WASTEWATER BASIS OF DESIGN REPORT

Museum Square Building 4 Scottsdale, Arizona

FINAL Basis of Design Report

7108 E. 2ND STREET
PRELIMINARY UTILITY PLAN
SCOTTSDALE, ARIZONA 85251

MUSEUM SQUARE PHASING EXHIBIT
UTILITIES
10/5/2021

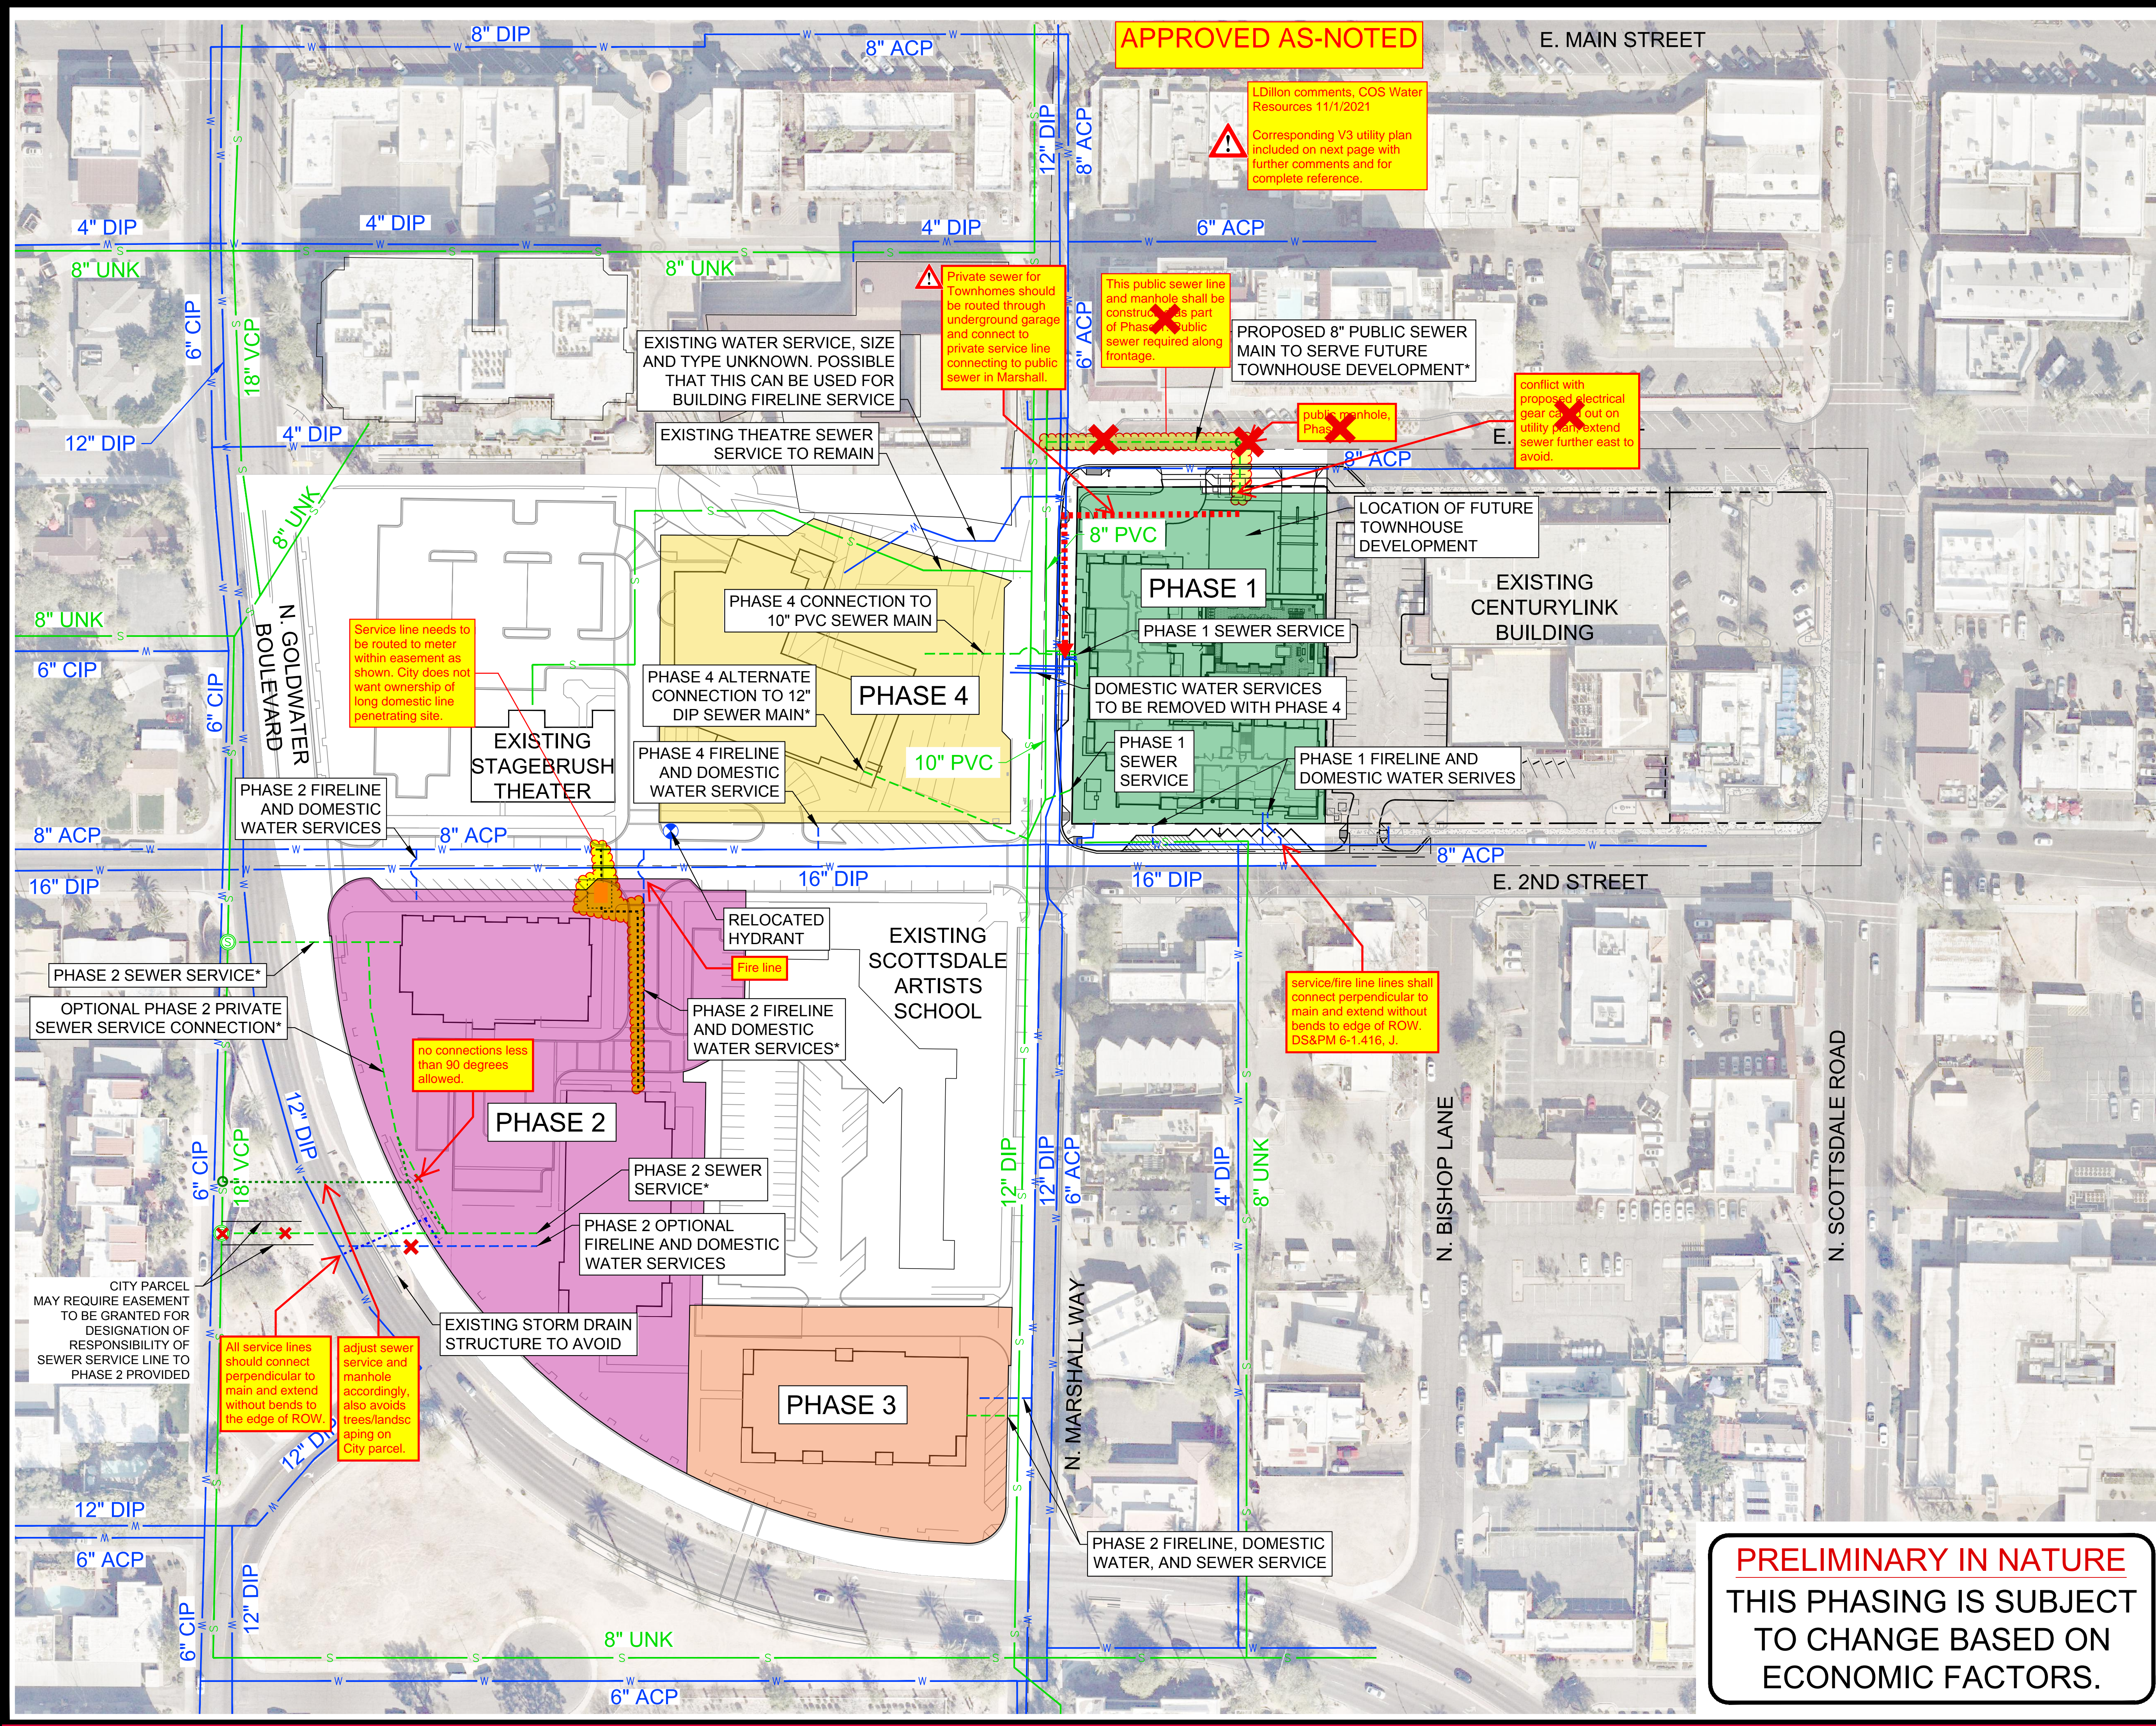
Added 11/4/2021
7) Stipulation: The sewer for the Phase 1 Townhomes shall be a private sewer within the onsite underground garage and outlet onto Marshall. Design for this sewer service shall be coordinated with Phase 1.

This figure was updated with following two pages on 11/4/2021 by LDillon

UT1
1 OF 1 SHEETS

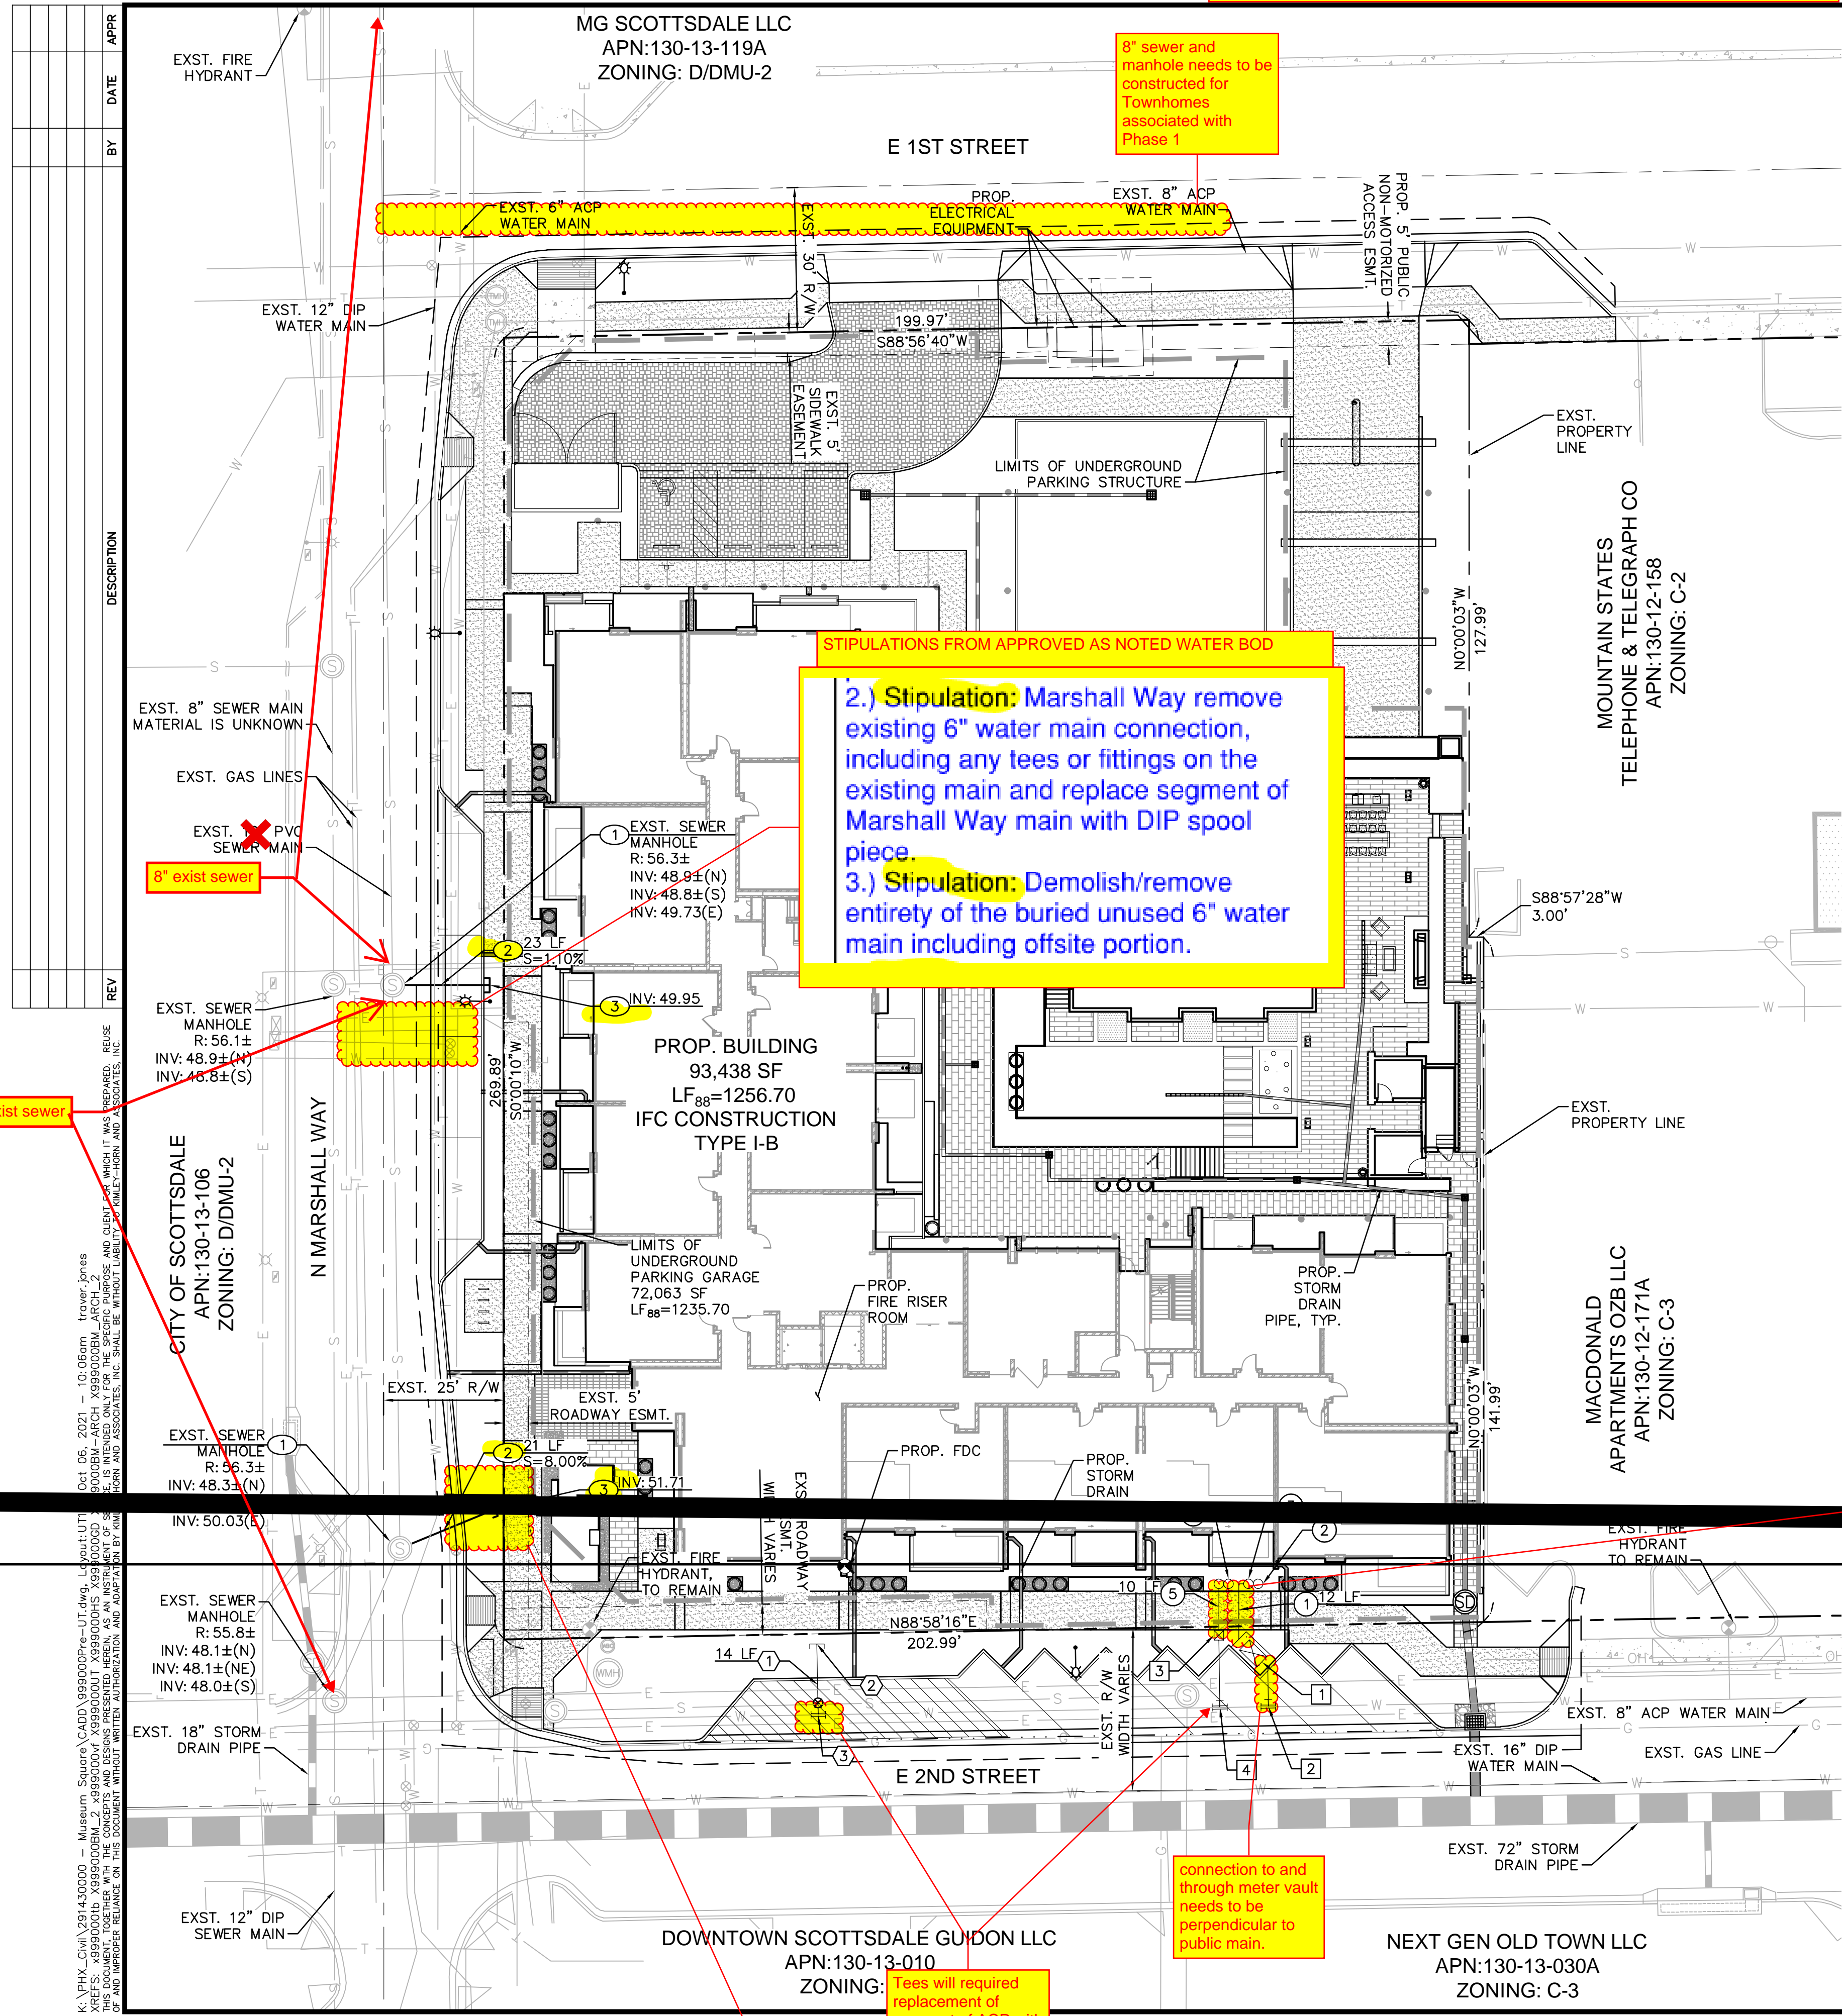
2.) Stipulation: Marshall Way remove existing 6" water main connection, including any tees or fittings on the existing main and replace segment of Marshall Way main with DIP spool piece.

3.) Stipulation: Demolish/remove entirety of the buried unused 6" water main including offsite portion.

MAG 440-3 is standard with CO in ROW. Double cleanout on private property may suffice. Defer to plan reviewer.

Need to call out double cleanout MAG detail.

Yes tee required

section shall have CLSM backfill if not adjacent to meter vault.

connection to and through meter vault needs to be perpendicular to public main.

Pool backwash shall be routed here per stipulation

Tees will required replacement of segment of ACP with DIP per City standard. Possibly will need to be done on tapping sleeves if too close to joint.
